# SDARS/WCS Rulemaking

**Sirius Satellite Radio Inc. & XM Radio Inc.**

**Technical Presentation to FCC International Bureau**

April 24, 2008

Figure 1. WCS Coalition proposed OOB mask for mobile CPE

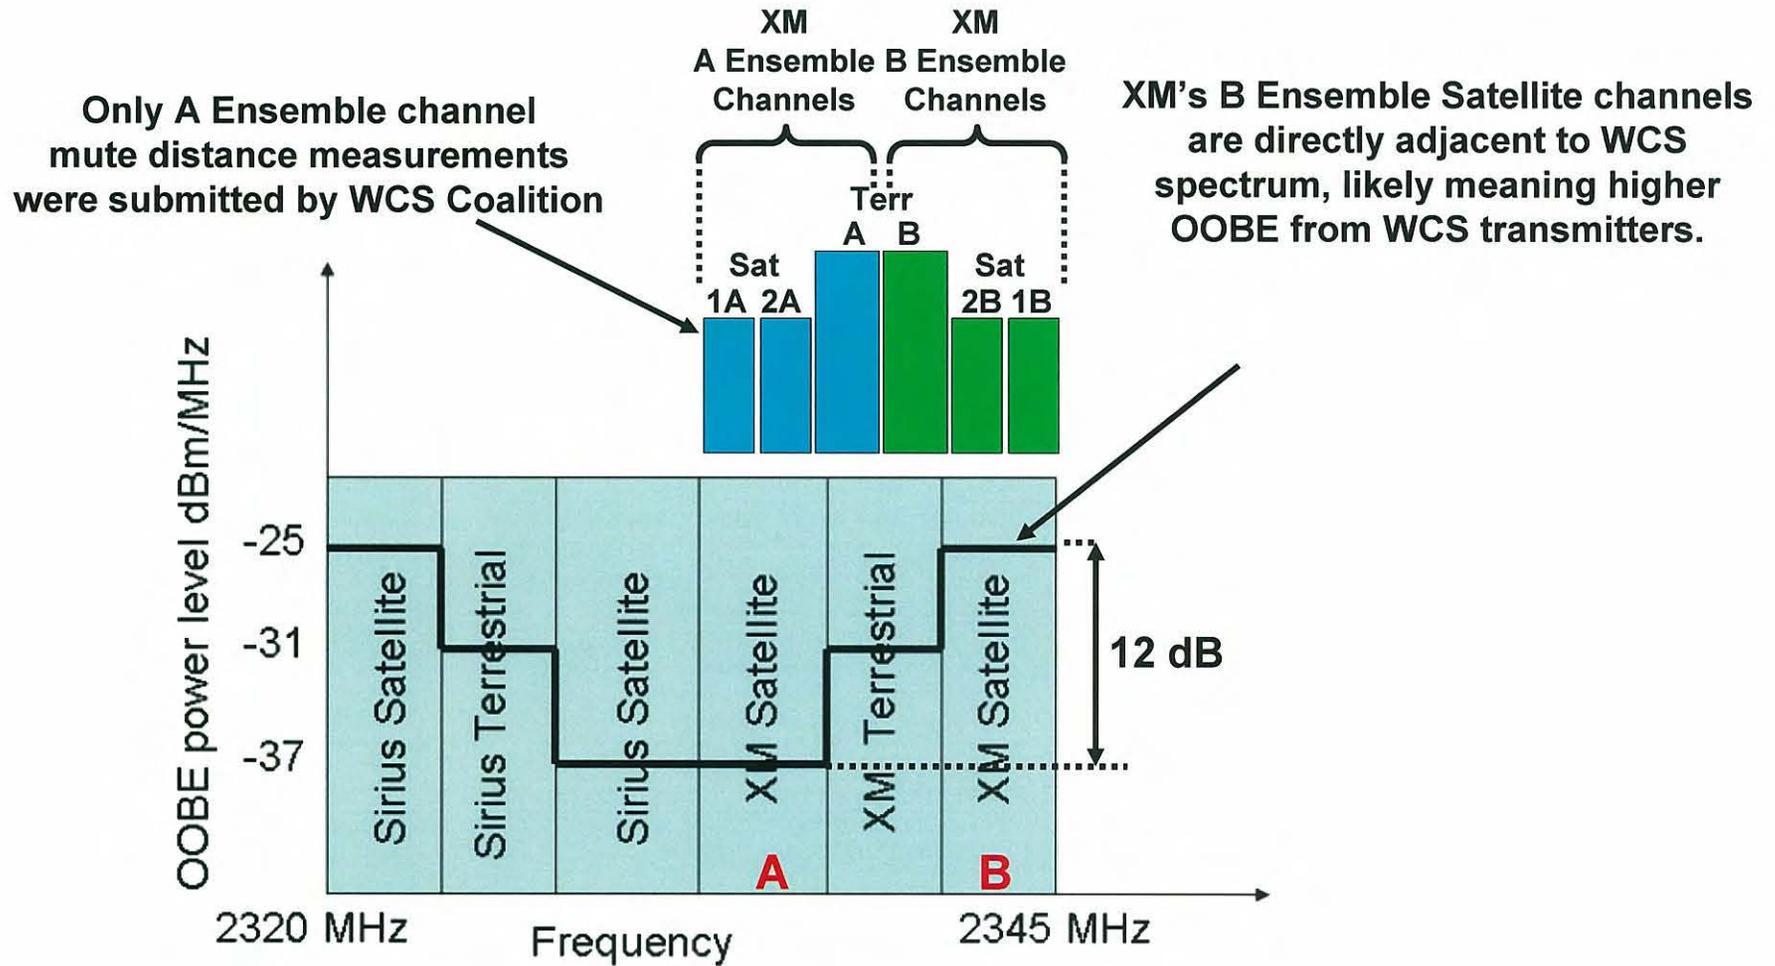
- Never measured interference to XM satellite channels located closest to WCS band (testing limited to “free” channel in Ensemble A)
  - Underestimated interference levels by 12 dB
  - Stepped OOB mask inappropriate, because it sanctions added interference to half of SDARS downlink channels.

In contrast, accurate tests should have a flat OOB mask.
- Best-case interference measurements result in overly-optimistic conclusions
  - Clear line-of-sight to SDARS satellites (no link margin sacrificed for foliage, terrain or other blockage)
  - Stationary receiver (no link margin sacrificed for fading)
  - Best case geographical test locations for strongest satellite signal (strongest possible sat signals for high  $S/(I+N)$ )
- In contrast, normal, real-world conditions with reduced link budget due to foliage, mobility, location, etc., will expand the WCS-generated muting zones.
